PLANS AND DOCUMENTS
referred to in the
APPROVAL
Dated: **17/01/2024**

AMENDED IN RED
6/11/2023

PROJECT
FLORENCE STREET DEVELOPMENT

ADDRESS
Lot 1 on RP9232
9 Florence Street
NEWSTEAD

CIVIL SITEWORKS
CONCEPT BULK EARTHWORKS PLAN

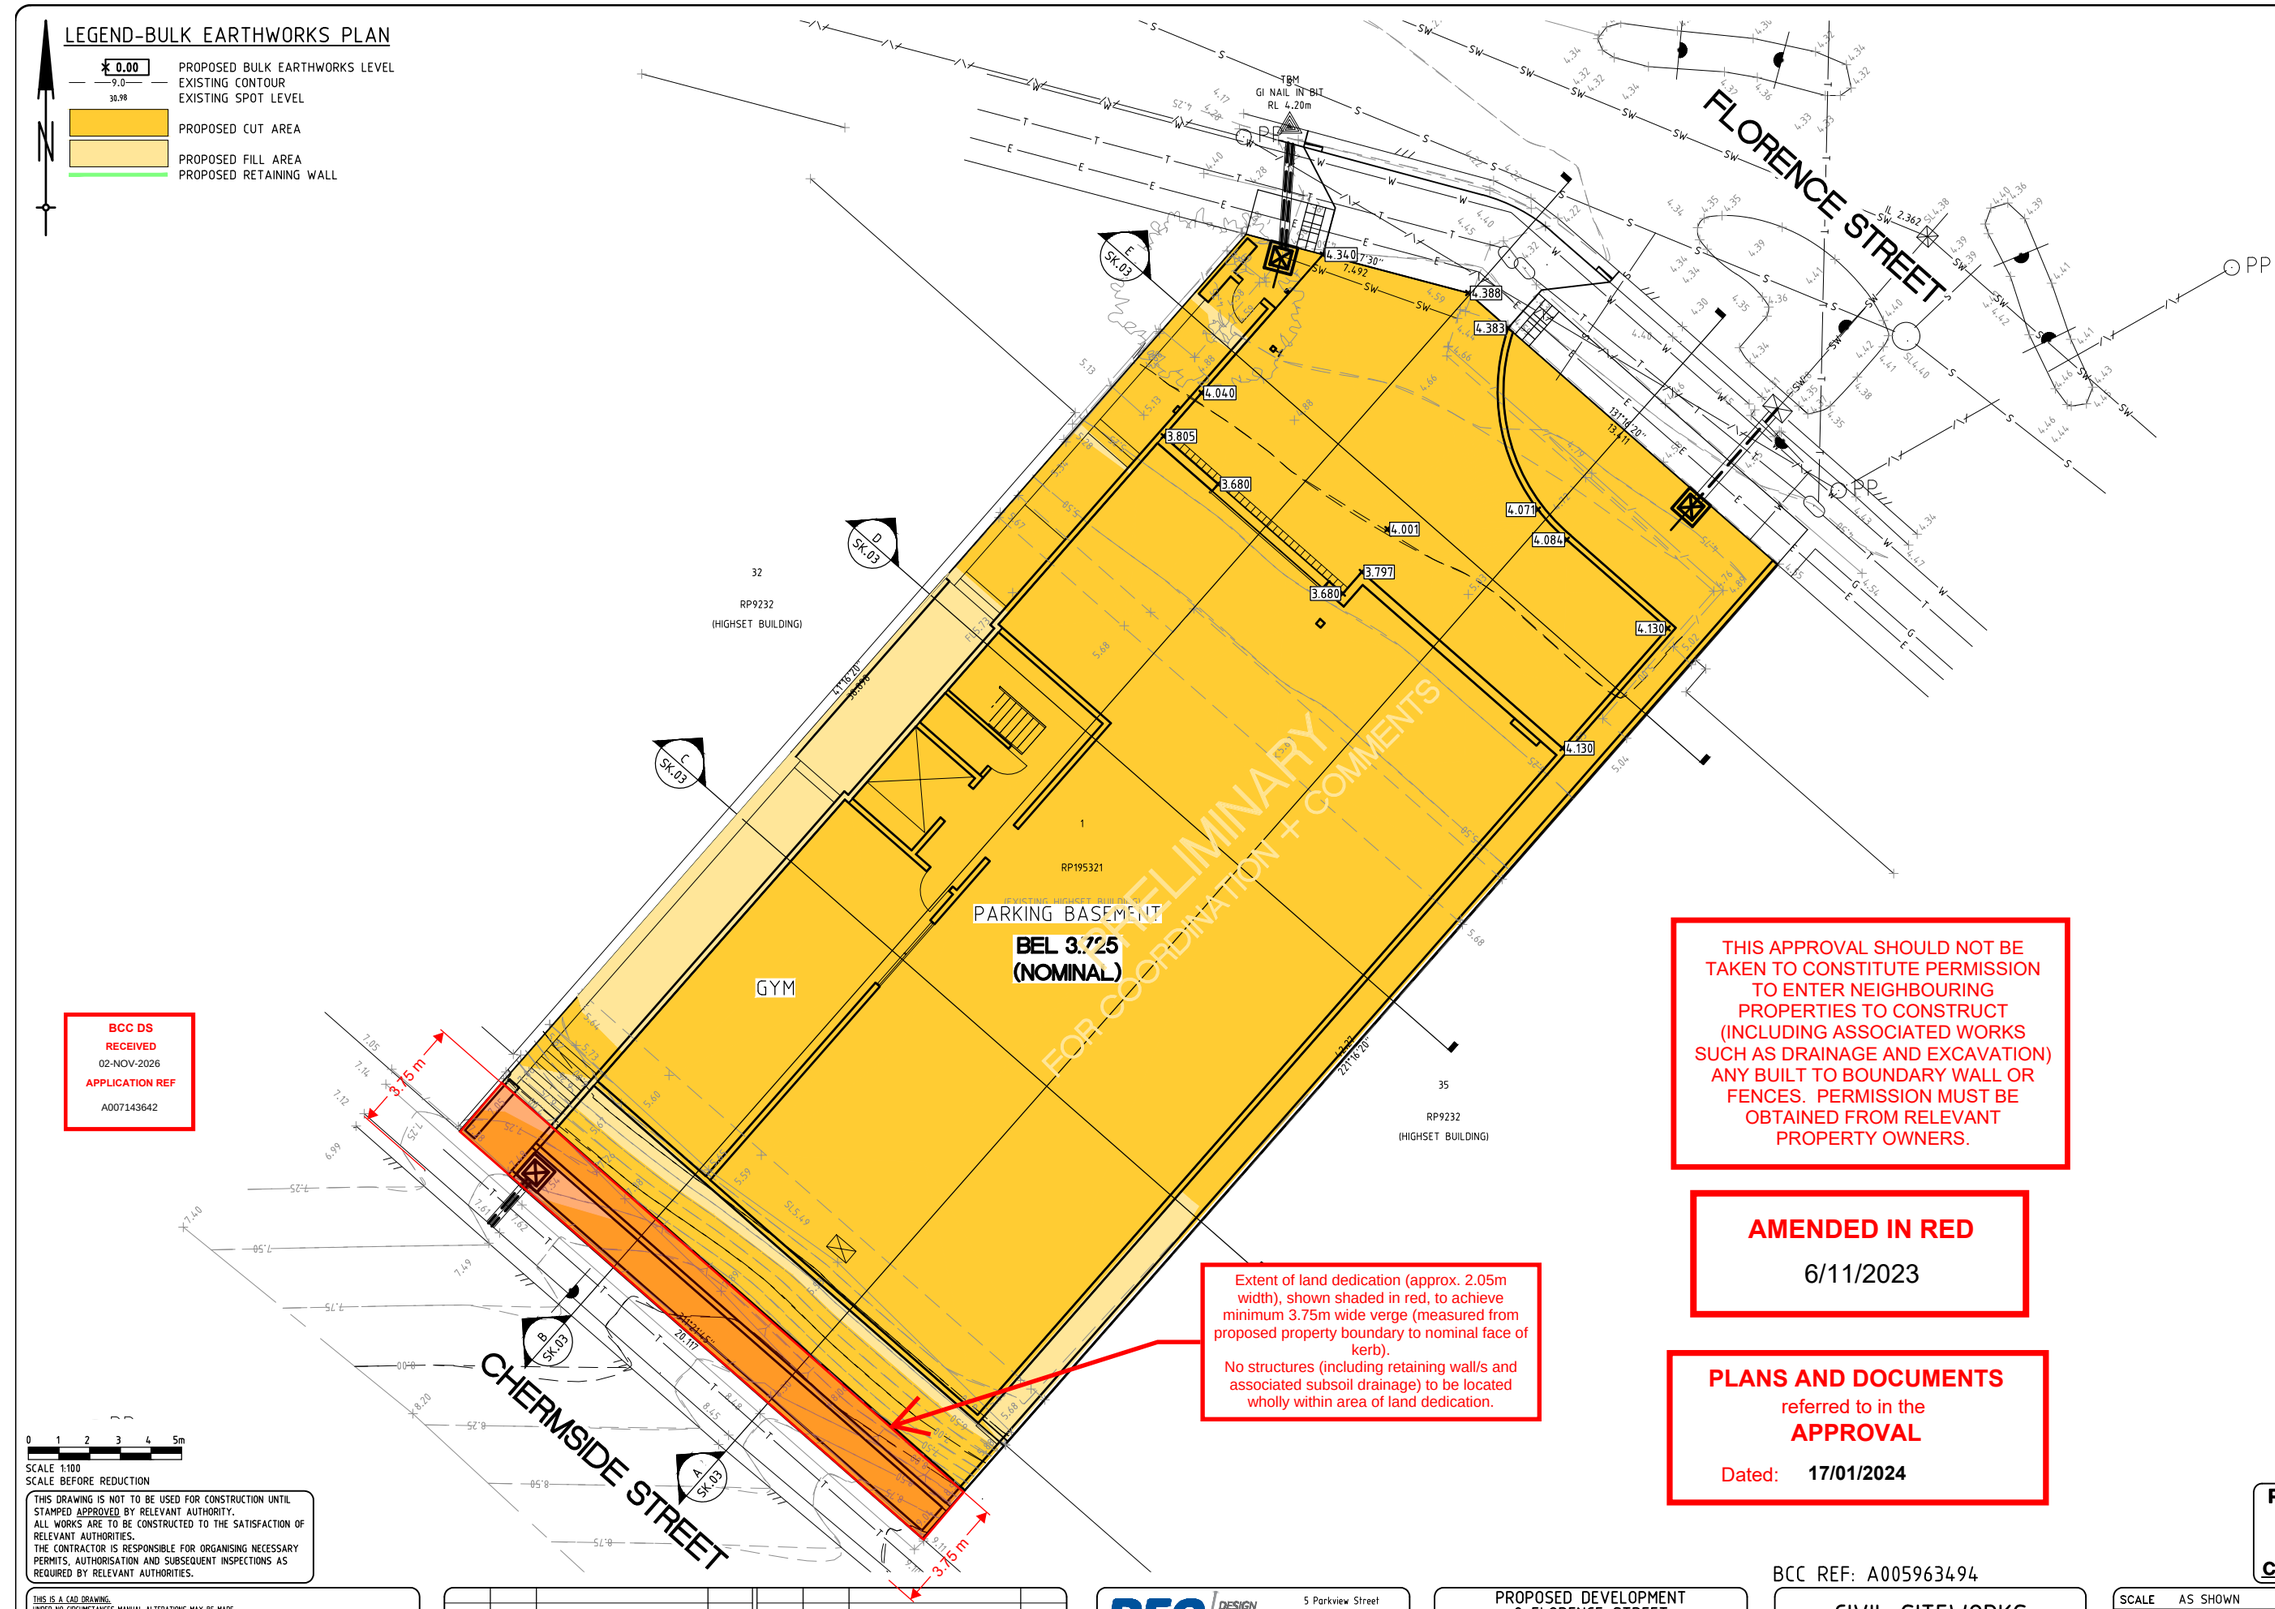
Extent of land dedication (approx. 2.05m width), shown shaded in red, to achieve minimum 3.75m wide verge (measured from proposed property boundary to nominal face of kerb).
No structures (including retaining wall/s and associated subsoil drainage) to be located wholly within area of land dedication.

CIVIL SITEWORKS
CONCEPT BULK EARTHWORKS CROSS SECTIONS

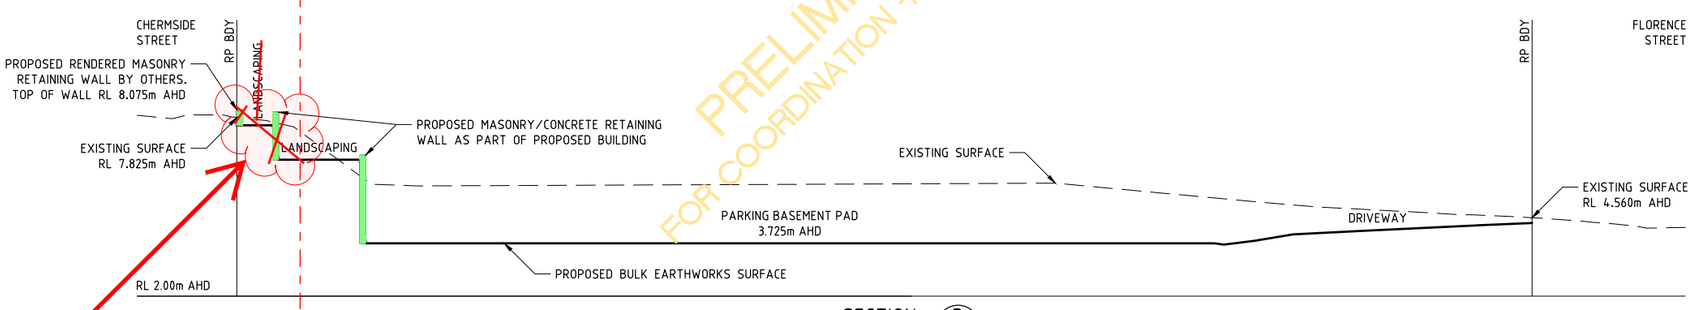
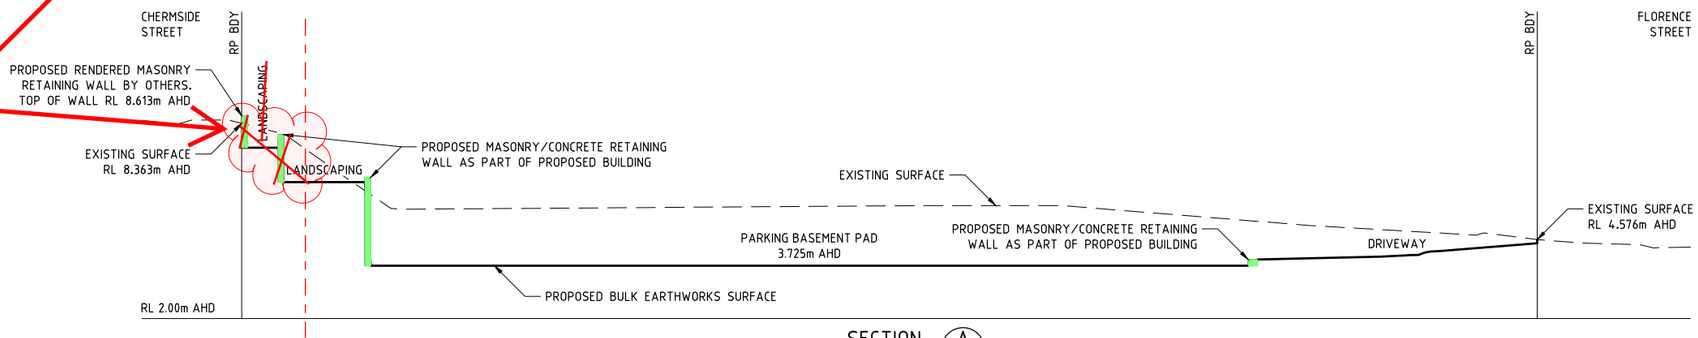
Construct verge with a suitable fall from the ultimate property boundary to the back of kerb. Approx. 2.05m widening required. Retaining wall (including subsoil drainage) to be wholly within property (taking into account land dedication/verge widening).
